STAFF REPORT
COMMUNITY DEVELOPMENT DEPARTMENT

HEARING DATE: 6/16/2022
 TO: Planning & Zoning Commission
 FROM: Joe Dodson, Associate Planner
 208-884-5533
 SUBJECT: H-2022-0001
 Pinedale Subdivision

Annexation and Zoning of 1.22 acres of land with a request for the R-8 zoning district and a Preliminary Plat for 7 building lots and 1 common lot on 1.22 acres in the requested R-15 zoning district, by Pine Project, LLC.

C. Landscape Plans (date: 5/11/2022)

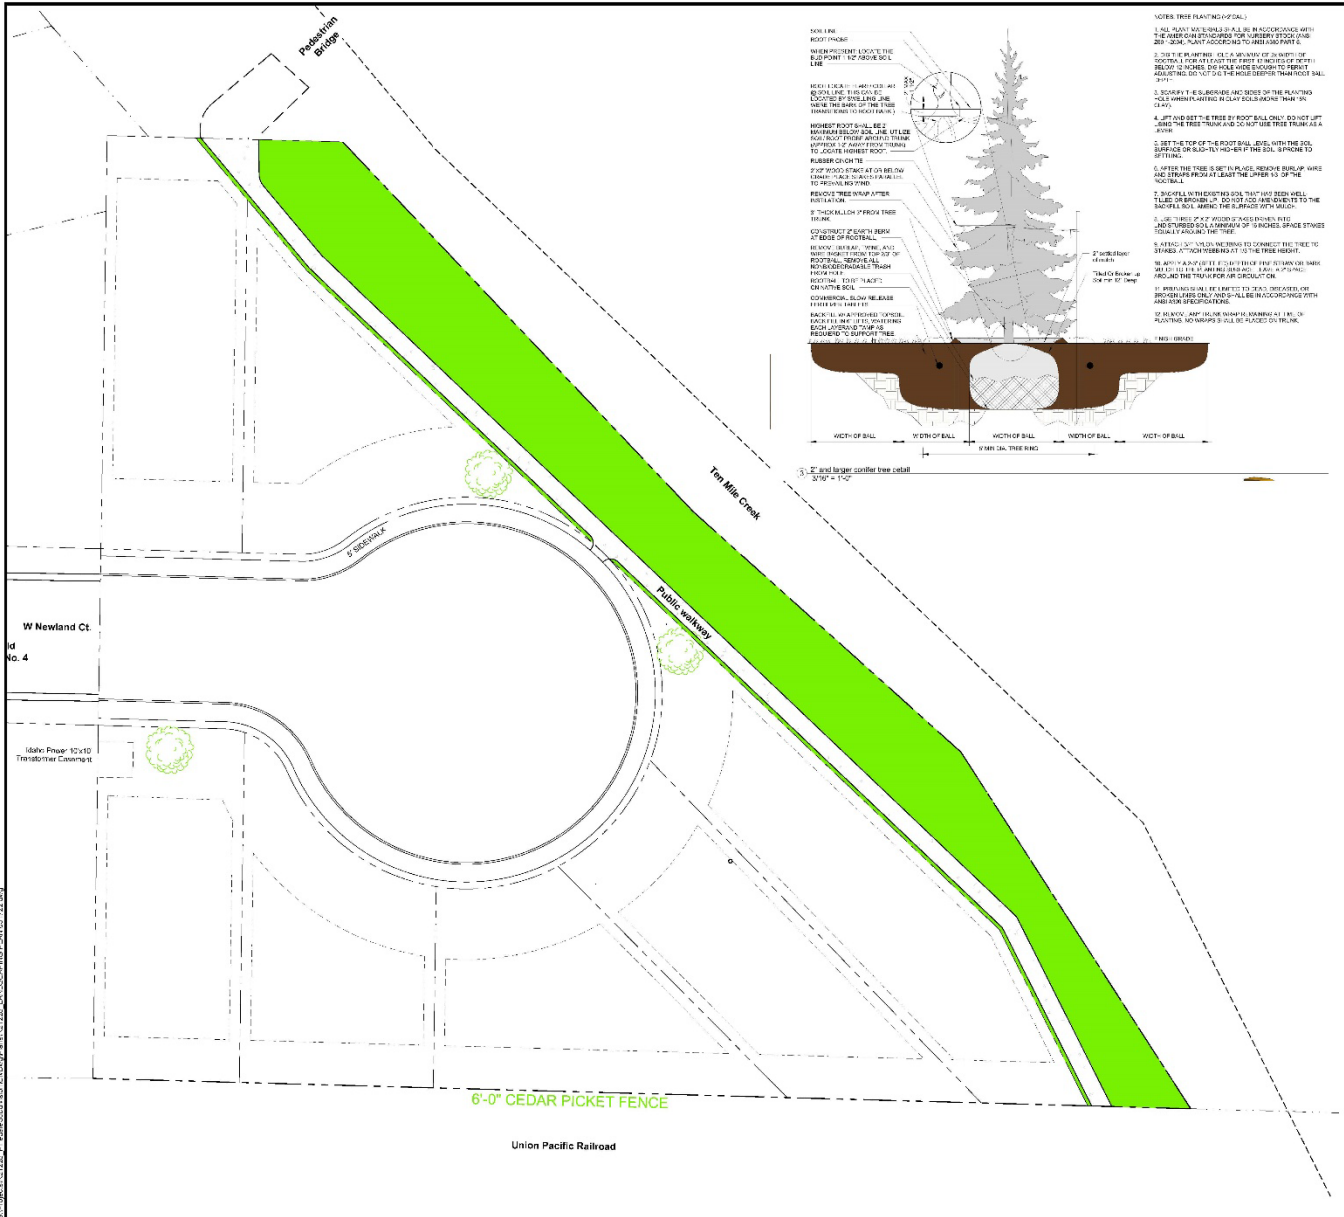
The landscaping regulated by code within the proposed development is the micro-path area along the eastern perimeter; this area is not required landscaping as the project is less than 5 acres. However, the Applicant should still comply with UDC 11-3B-12 standards. The submitted landscape plan shows this area to be vegetated with grasses and no trees due to it being within the Tenmile Creek irrigation easement; the linear length of the micro-path requires 4 trees to comply with UDC 11-3B-12. Furthermore, the main purpose of this micro-path is to have access to the multi-use pathway at the north boundary which will have shade trees along its entire length up to Fuller Park. The Applicant should revise the location of this micro-path and work with the irrigation district to allow for the required trees along the east property lines at the furthest western edge of the irrigation easement. If the Applicant cannot obtain a license agreement with NMID to allow these 4 trees, the Applicant should submit for Alternative Compliance with the future final plat submittal to propose an alternative.

All fencing is required to comply with the standards listed in UDC 11-3A-7 and 11-3A-6. Fencing is proposed as shown on the landscape plan and does not meet UDC standards.

6-foot tall wood fencing is proposed along the perimeter of the project—this complies with code for all areas except the east property lines adjacent to the Tenmile Creek irrigation easement. With the final plat submittal, the Applicant should revise the landscape plan to show open-vision fencing or semi-private open vision fencing along the east property lines of Lots 2 & 3. In addition, the Applicant should clarify if any fencing is proposed along the Tenmile Creek itself and coordinate with Nampa Meridian Irrigation District on where they would like any fencing located within their easement.

- a. Depict open vision or semi-private vision fencing along Lots 2 & 3 in accord with UDC 11-3A-7A.7 standards.
 - b. Depict fencing along the Tenmile Creek in compliance with UDC 11-3C-6C or submit proof from NMID that fencing is not allowed.

- c. Revise the landscape plan to show the micro-path in Lot 8 to be shifted at least 5 feet away from the proposed property lines so at least 4 trees can be added on its west side, consistent with UDC 11-3B-12 standards.
